FORD:

2014 F-150

ISSUE

Figure 1 - Article 14-0103

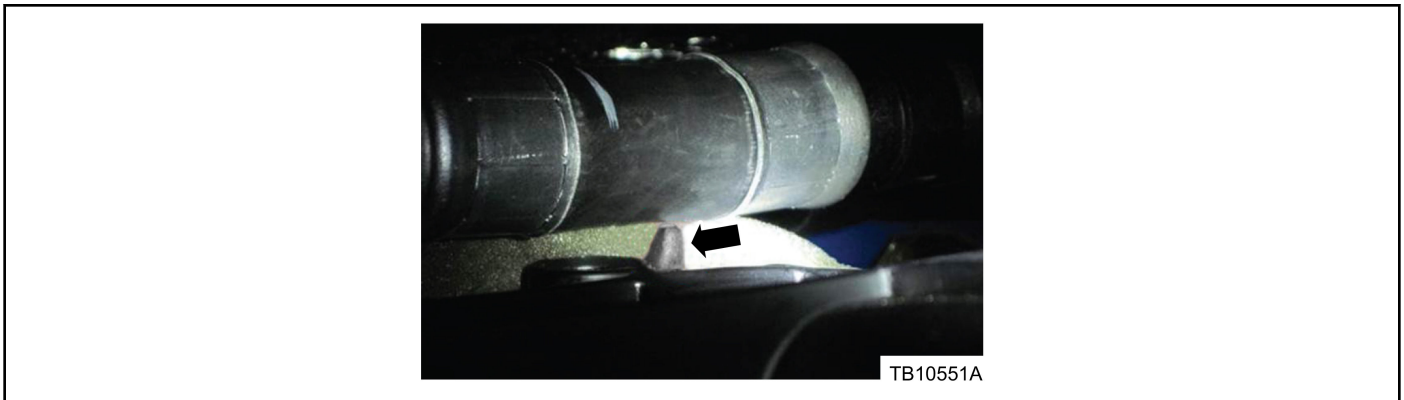
1. Inspect the small heater hose near the bulkhead and intake manifold area.
2. Is the heater hose leaking and/or exhibiting signs of contact with the intake manifold? (Figure 1)

- a. Yes - replace the heater hose and refill the cooling system. Refer to Workshop Manual (WSM), Section 303-03. Proceed to Step 3.
 - b. No - proceed to Step 3.
3. Using a frameless handheld hacksaw with a metal blade, trim the casting boss from the intake manifold flush with the adjoining sensor mount. (Figures 2 and 3)

Figure 2 - Article 14-0103

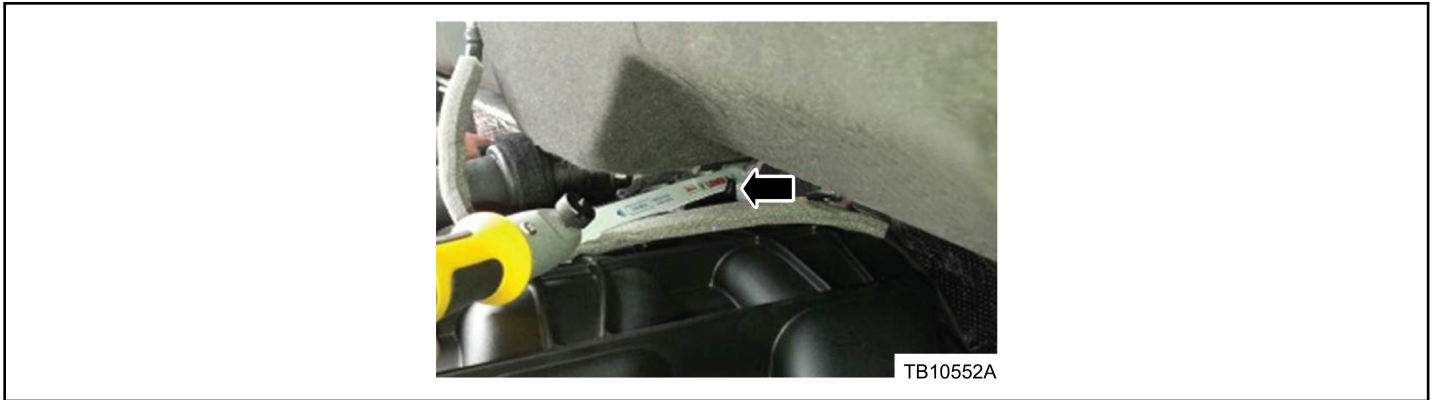
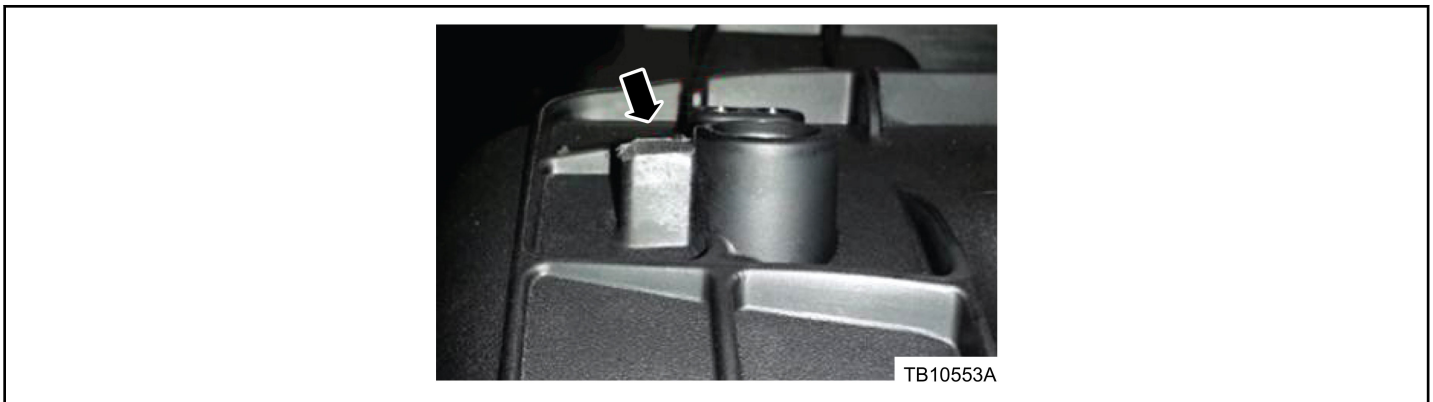
Some 2014 F-150 vehicles equipped with a 3.7L engine and built 1/23/14 and through 3/30/14 may exhibit a coolant leak at the rear of the engine at the heater hose. In certain conditions the heater hose may contact the intake manifold and create a coolant leak.
